**Economic and Social Council**Distr.: General
22 September 2015

Economic Commission for Europe**Inland Transport Committee****World Forum for Harmonization of Vehicle Regulations****Working Party on Passive Safety****Fifty-eighth session**

Regulation No. 129 (Enhanced Child Restraint Systems)**Proposal for the 01 series of amendments to Phase 1 of
Regulation No. 129 (Enhanced Child Restraint Systems)****Submitted by the expert from France***

Paragraph 7.1.3.1.3.2., amend to read:

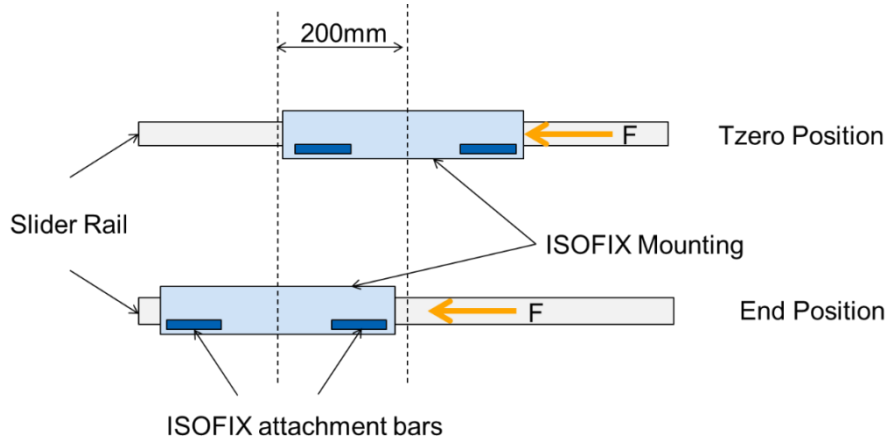
"7.1.3.1.3.2 The lower ISOFIX anchorages should be movable in the Y direction to avoid damage to the attachments and test equipment. The ISOFIX anchorages shall be fixed to a sliding system allowing a movement of 200mm -0mm +50mm. **When measured with a dynamometer at a rate of 600-1200mm/min positioned in a plane parallel the sliding surface and aligned to the central axis of the sliding surface, the force required to move the sliding system (both anchorages together) throughout its entire range, shall not exceed 100N. This verification shall be performed every 50 tests or every 6 months whichever occurs first.**

Figure 1
Dimensions in mm of the seat and the seat cushions

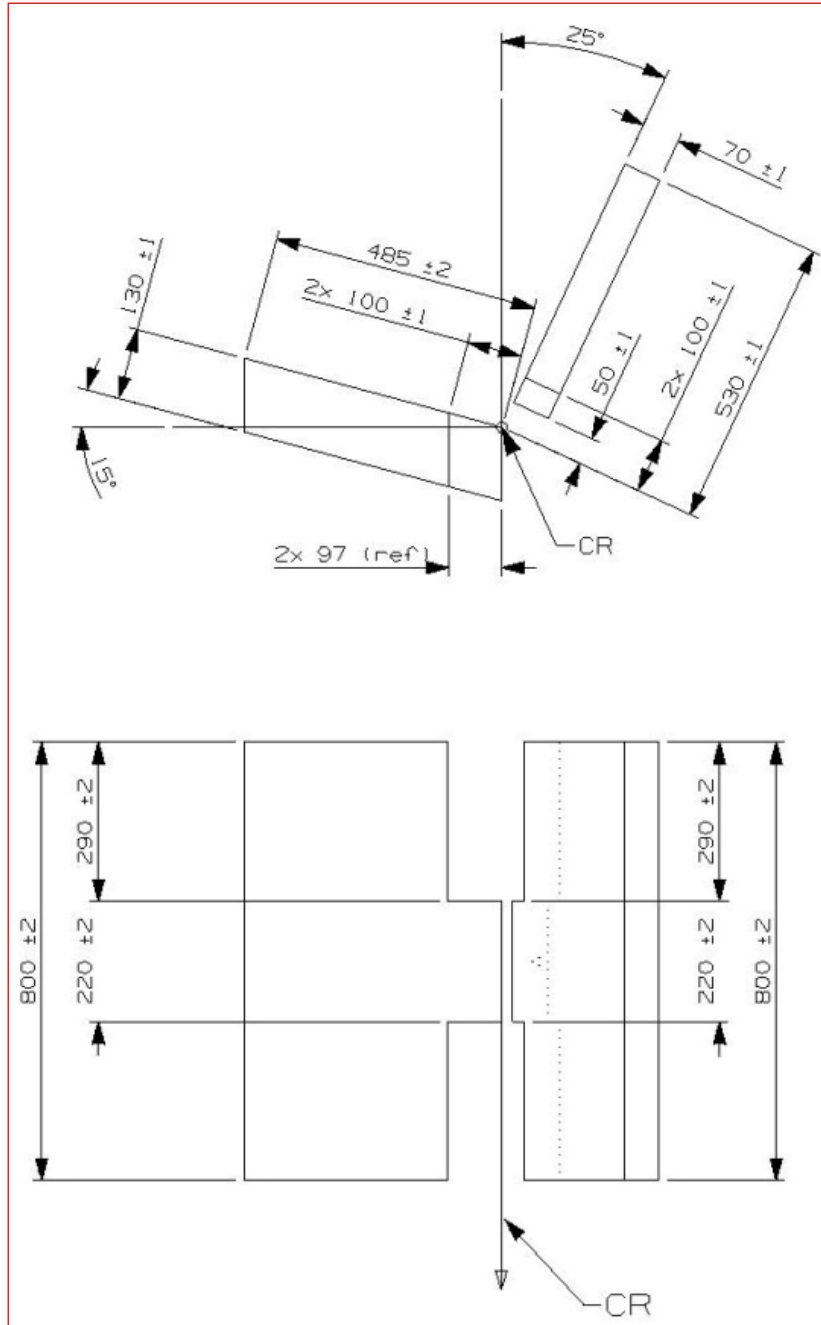
"3.1.2. Rigid seating, **made from a rigid metal sheet**, dimensions of which are given in Appendix 1 to this annex. ~~The rear part of the seating is made from a rigid sheet metal. The front part of the seating is also made of a 20 mm diameter tube;~~"

Door panel geometry and position at T0 – Top view

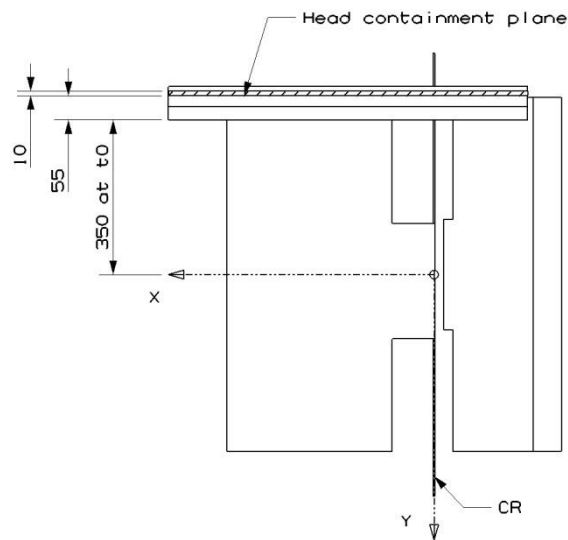
The impact surface of the door panel shall be entirely covered with a padding material of 55 mm in thickness (see Figure 1 above). The material shall comply with the performance criteria specified in paragraph 2.3. (figure 4 below) of this appendix when tested in accordance with paragraph 2.2. of this appendix.

Figure 4

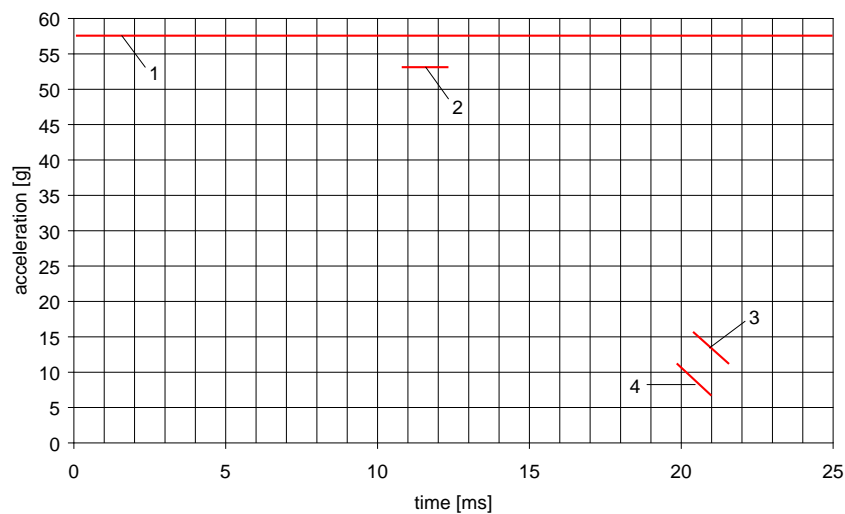
The impactor acceleration shall not exceed 58 g.

Annex 17, paragraph 1.2.4., amend to read:

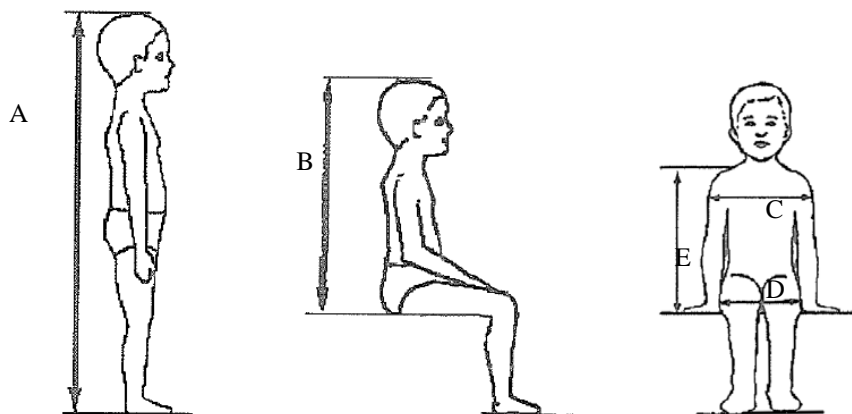
"1.2.4. values of HPC for which the time interval (t1 - t2) is greater than ~~36~~ **15** ms are ignored for the purposes of calculating the maximum value."
